Groundwater & Wastewater Services
Septic Project File & Data Review Worksheet

GWS File #: 2074 WASPS App #: 74143

IMPROVEMENT PERMIT for a RESIDENTIAL ON-SITE WASTEWATER TREATMENT & DISPOSAL SYSTEM

Permit #: **30002874** GWS File #: **7414B** Tax Parcel #: **139-161-08**

M.C.G.W.S.
File: 7414-B
Lot 26 Old Camden Est.

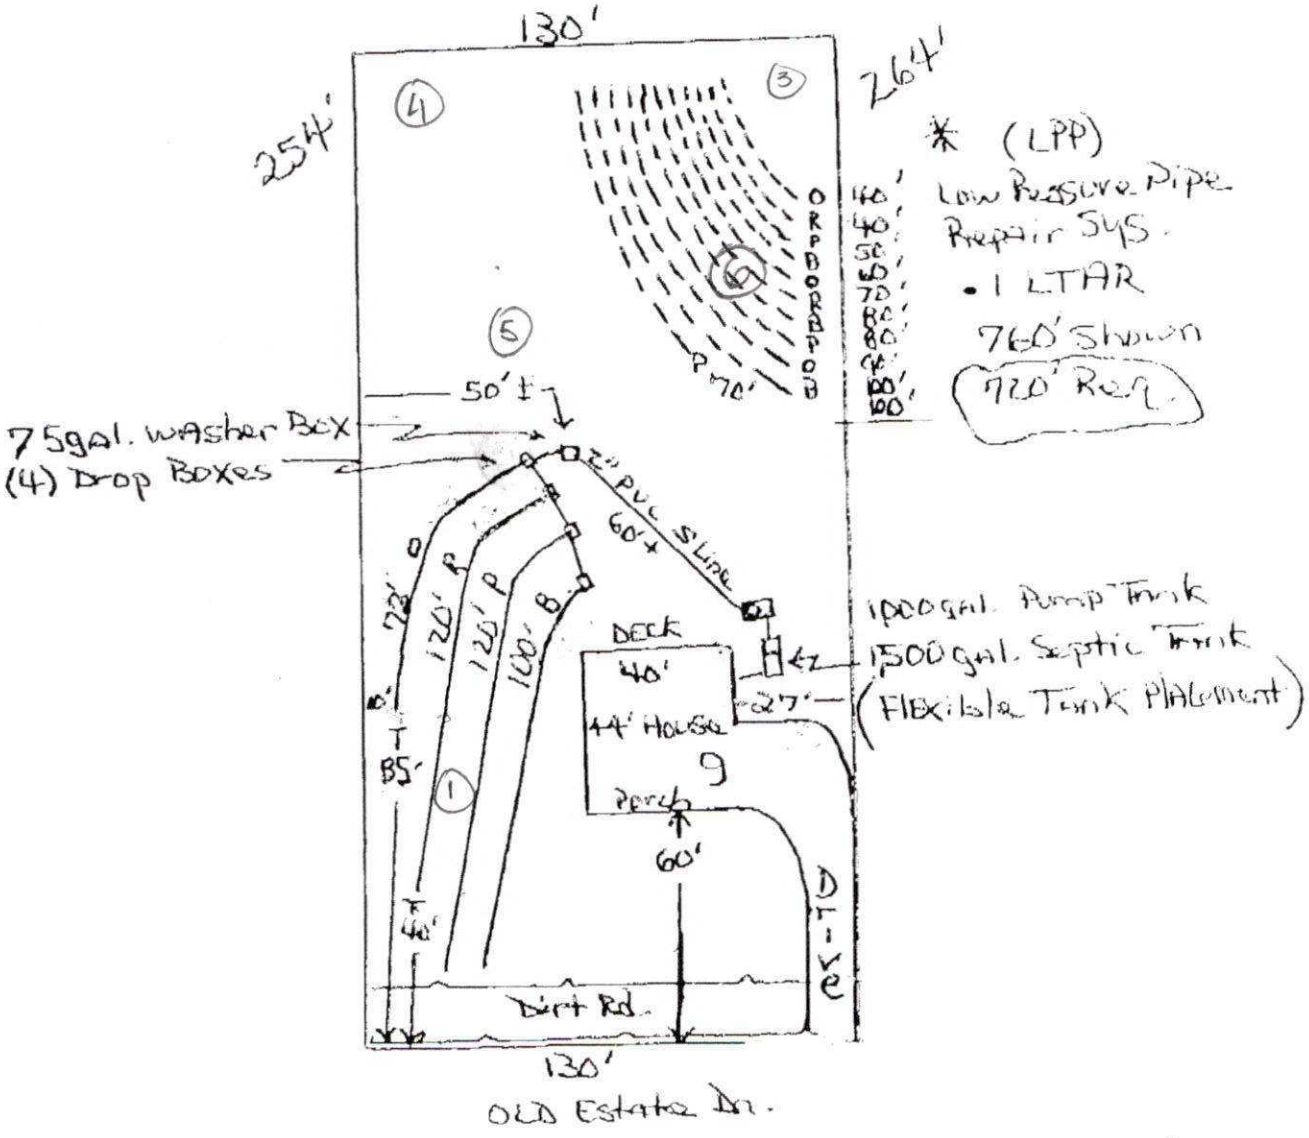
(3) Bedrm. 25% Reduction Septic Sys. LTAR .225
Quick Four Chamber.
1,500 gal. Septic Tank, 1,000 gal. Pump Tank, 75gal.
Washer Box, (4) Drop Boxes
(4) Chamber Lines at 72', 120', 120, 100' = 412'
(103) Chambers Req.
* Shallow Placement At 17" (See SPEC Sheet)

2/4/09
FIELD REVIEW: APPROVED
